Subject: Highway Occupancy Permit Application No. 126109 Returned For Revisions

Response Comments
Date: 03/24/2017
Application Number: 126109

HIGHWAY OCCUPANCY PERMIT PLANS
FOR
STONEY CREEK RENTALS

SR1010 (PARK ROAD)
MAIDENCREEK TOWNSHIP, BERKS COUNTY, PENNSYLVANIA

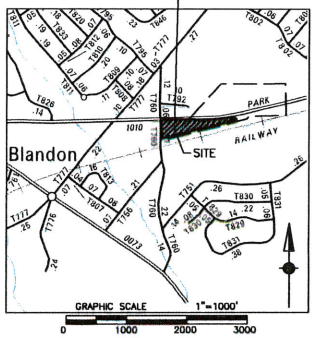
Please increase text size
Minimum is 0.12" per
Design Manual Part 3

Not required if no physical work in PennDOT is proposed

verify - see sheet 2

Use current logo
Refer to sample
Bill sheet in EPS

Provide scan of original seal and signature

PLAN

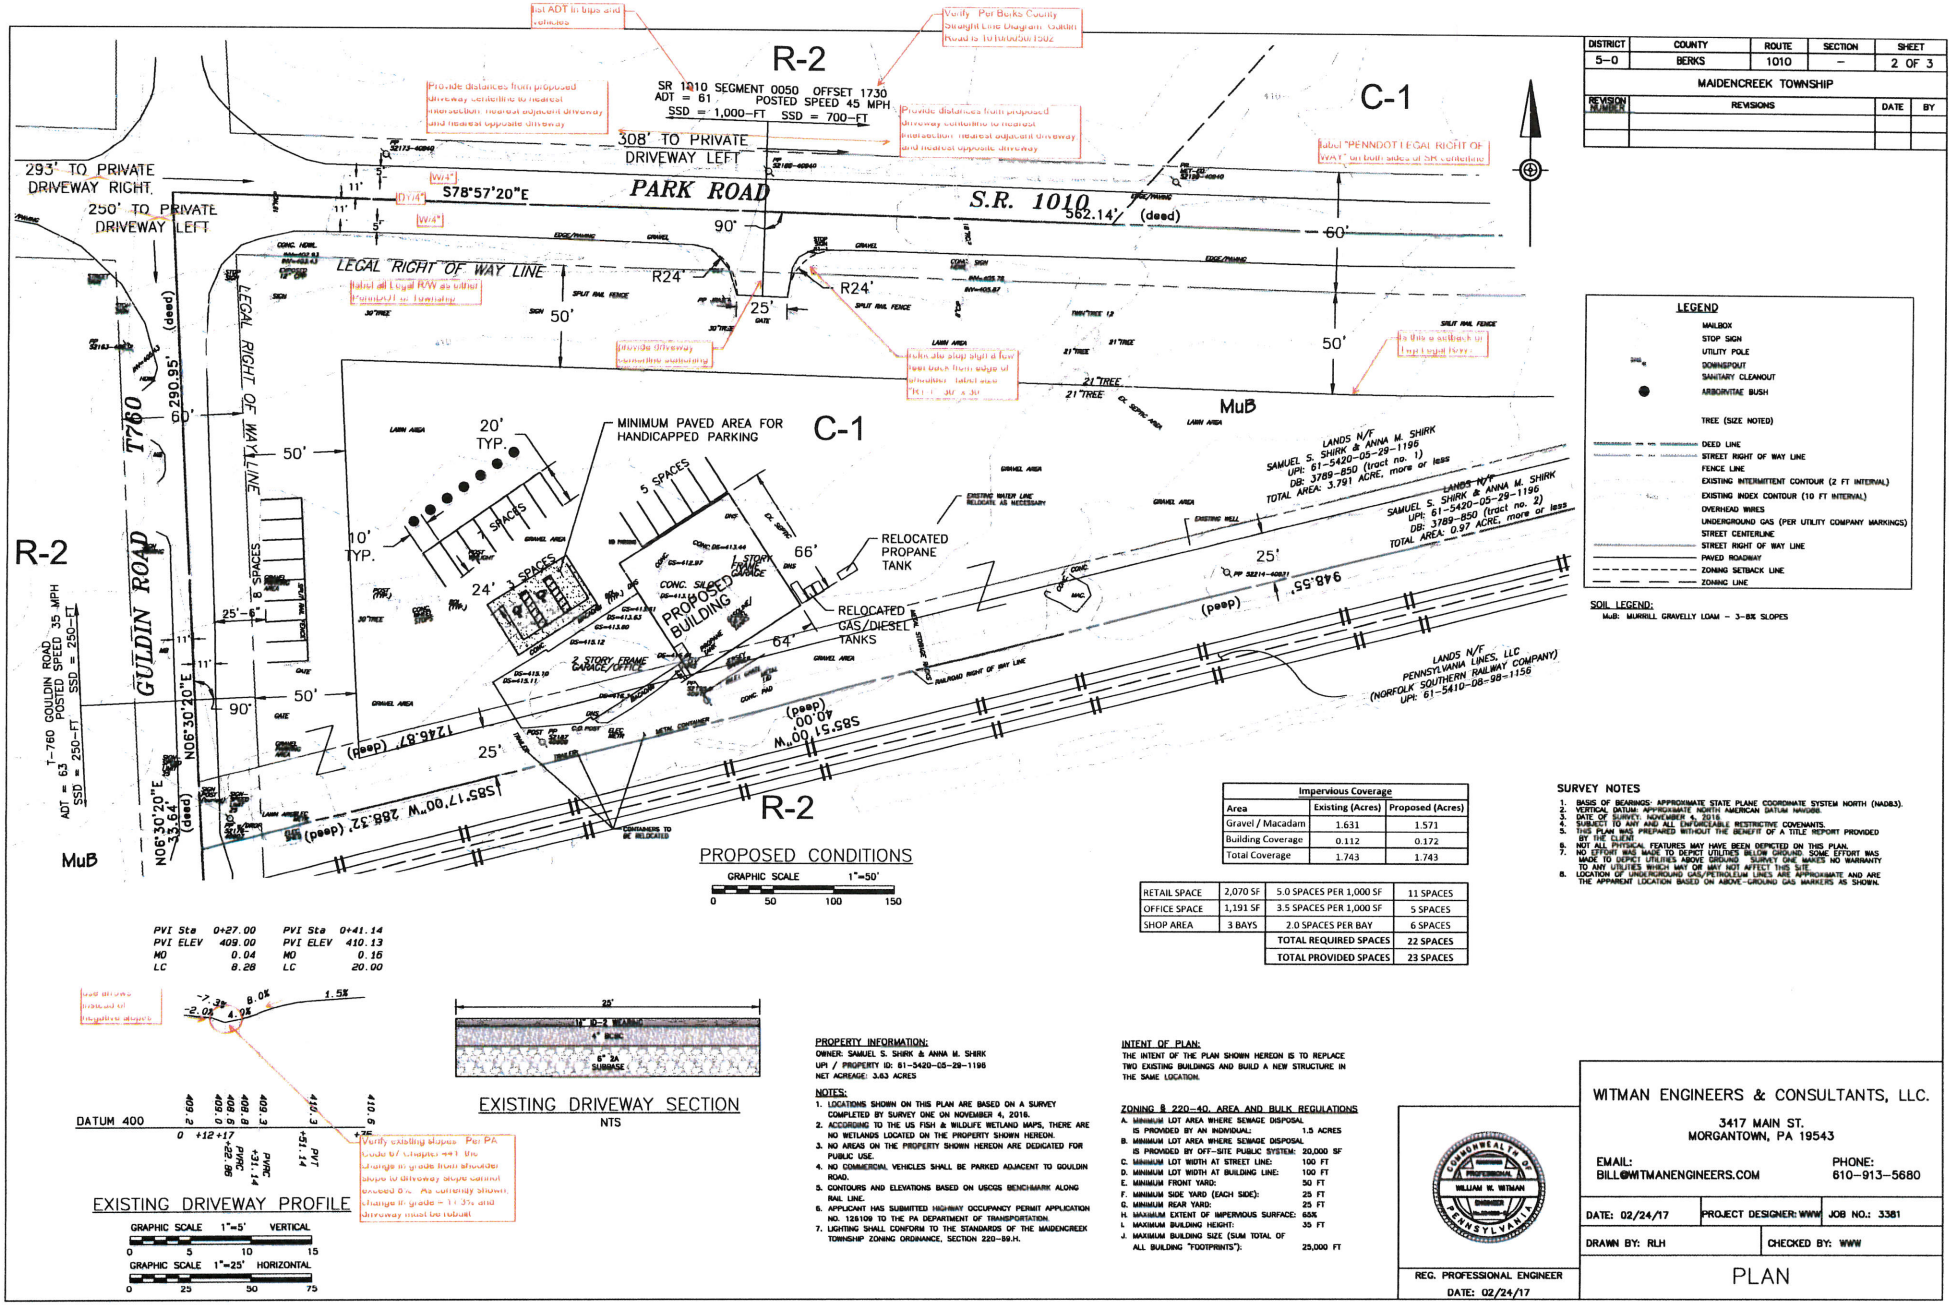
(1) Provide the distance from the driveway to the nearest intersection and to the nearest driveway on both sides of the road on the plans. Pa Code, Title 67, Chapter 441.3. Refer to attached markups for clarification.

(1) Revise the plans such that the difference between the cross slope of the shoulder and the grade of the driveway does not exceed eight percent. If it is not practical for a grade difference of eight percent or less to be achieved, a vertical curve must be provided in accordance with Figure 1 of the (Pa. Code, Title 67, Chapter 441.8(i)(4) and Figure 1)

(1) A "Stop" sign (R1-1) sized 30" x 30" should be shown for the driveway exit.

(1) Label all existing pavement markings within the project limits on the plans. Pa Code, Title 67, Chapter 441.3(i)(1)
